Independent Review of QT-040398 PCB Pre-production Report

Document No. : EN-152231-1

Project no. : QT-040398

Figure 1 Job information in schemati drawing

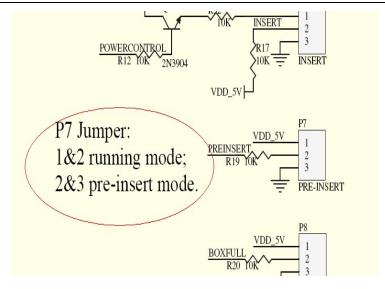
3.1 It is recommended to input the job name, reversion number in the schematic drawing.

Figure 1 Power via should be larger

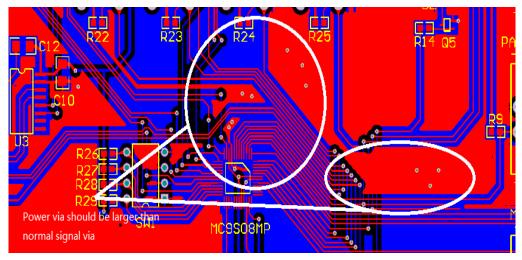
4.1 It is suggested to use 20 to 28 mils Via for these traces connect to power/ground plane. The current design shows the diameter of these vias are only 15 mils. Large vias connected to the power/ground plane leads to better power supply performance.

Figure 4 Single end track

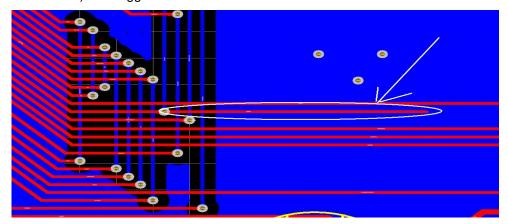
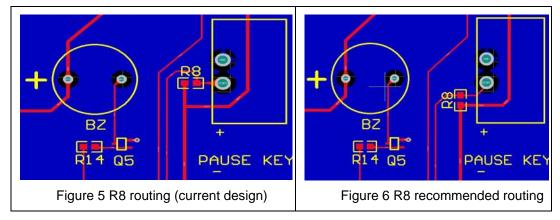
4.6 The trace shown on below figure doesn't connect to anything after crossing the via (net name: START). It's suggested to delete these extra trace on the board.

Figure 3 Label should be with function

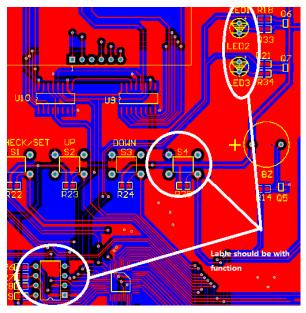
5.2 It's suggested to show the configure information for these switches, jumpers and LEDs on silkscreen layer.

Figure 14 Use the same width trace connect to the part

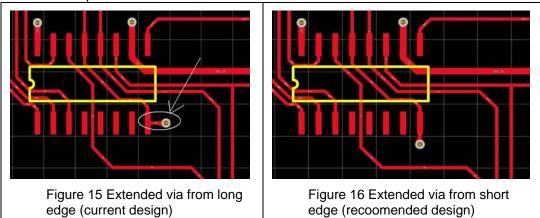
8.1 It is recommended to chose the same width value for the traces connected with R22,R23,R24, and R25. From the manufacture point of view, it is always better to use the same width traces connect to one part.

Figure 5 Via should not be so near to pad

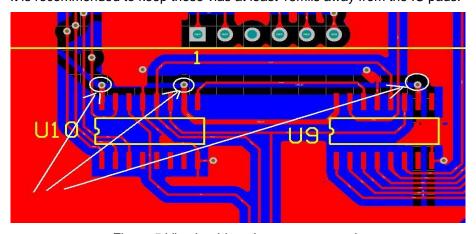
9.1 It is recommended to keep these vias at least 15mils away from the IC pads.

Figure 17 Drill hoel on the pad

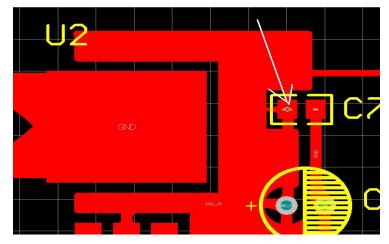
9.2 There is a 10mils size via in the central of one of C7 pads. It is suggested to delete it from the pad. The flux could sink into this hole during the reflow soldering process. Practical experience shows drilling hole on the pad could be the root reason of the fake welding.
